Service Bulletin

Bulletin No.: PI0873

Subject: Malfunction Indicator Lamp (MIL) Illuminated, DTC P0442 and/or P0455 Set

Models: 2012-2013 Chevrolet Express 3500-4500 Cutaway Vans
2012-2013 GMC Savana 3500-4500 Cutaway Vans
Equipped with Upfitter Body and Side Mounted Fuel Tank

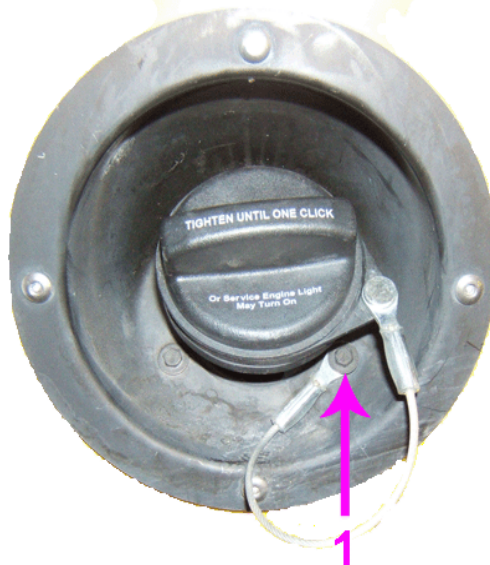
This condition may be caused by the fuel cap tether binding when installing the fuel cap and not allowing the fuel cap to seal completely or by the fuel cap tether being trapped between the fuel cap seal and the fuel fill pipe, not allowing the fuel cap to seal completely.

The fuel cap tether will need to be repositioned from its current attachment point within the fuel fill pipe housing to the external 3 o'clock position on the fuel fill pipe housing edge.

3217803

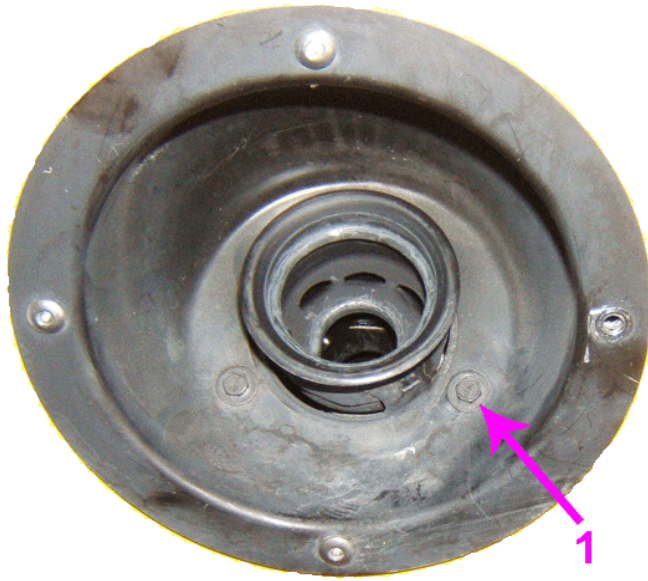
4. Remove the fuel cap tether fastener (1) from its attachment point within the fuel fill pipe housing.

5. Reinstall the fastener (1) to its original attachment point within the fuel fill pipe housing.

3217919

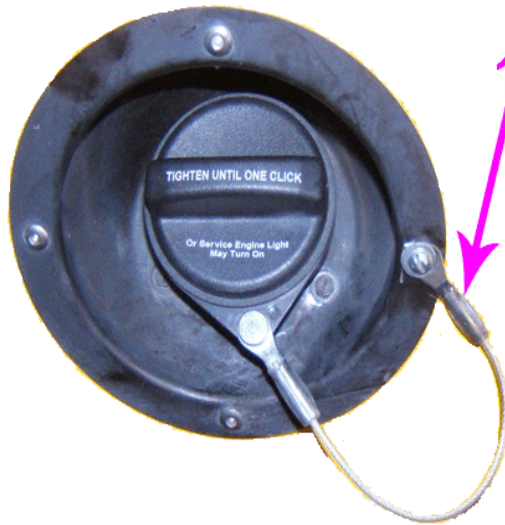
6. Remove the fastener at the external 3 o'clock position on the fuel fill pipe housing edge.

7. Install the gas cap.
 - 7.1. Orient the fuel fill cap tether, with the crimp side (not shown) of the tether terminal (1) **towards** the vehicle box as shown.
 - 7.2. Install a new fastener through the fuel fill cap tether terminal into the external 3 o'clock position attachment point on the fuel fill pipe housing edge and secure it.
8. Clear the DTCs with a scan tool.
